Office Action Summary

10/581,670

DETAILED ACTION

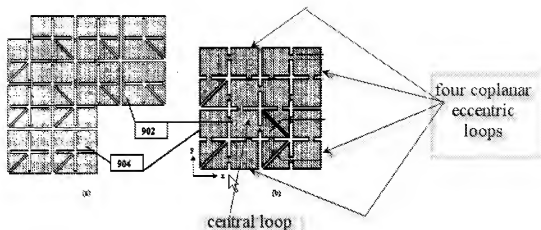
Respecting claim 1, Diaz discloses, in Fig. 17 or the below drawing, a central loop (a loop 804 in layer 902) and coplanar eccentric loops (four loops 804 in layer 904), the antenna comprises four adjacent coplanar eccentric loops, the centres of gravity of the eccentric loops being arranged substantially on the periphery of the central loop. Claim 1 recites the central loop (1) creating “a magnetic field essentially perpendicular to the antenna”, and “supplied in such a way as to create a rotating field predominantly in a plane parallel to the plane of the antenna”. Diaz discloses the same structural configuration as the claimed invention. Therefore, although not explicitly stated in Diaz, it is inherently that the central loop and four coplanar accentric loop of Diaz would create a magnetic field essentially perpendicular to the antenna and create a rotating field predominantly in a plane parallel to the plane of the antenna as claimed.

Respecting claim 2-3, Diaz discloses the same structural configuration as the claimed invention. Therefore, although not explicitly stated in Diaz, eccentric loops (804 in layer 904) are associated in pairs of non-adjacent loops inherently generate electromagnetic fields of opposite phases in said pair, and the two eccentric loops of a pair are connected so that a same current is inherently flowing through them in opposite trigonometric directions.

Respecting claims 4-7, Diaz discloses the four eccentric loops are arranged symmetrically with respect to the centre of the central loop, and central loop and the eccentric loops (2) are substantially rectangular or triangular, an apex of each triangle being located in the central zone of the antenna (col. 9 lines 45-50).
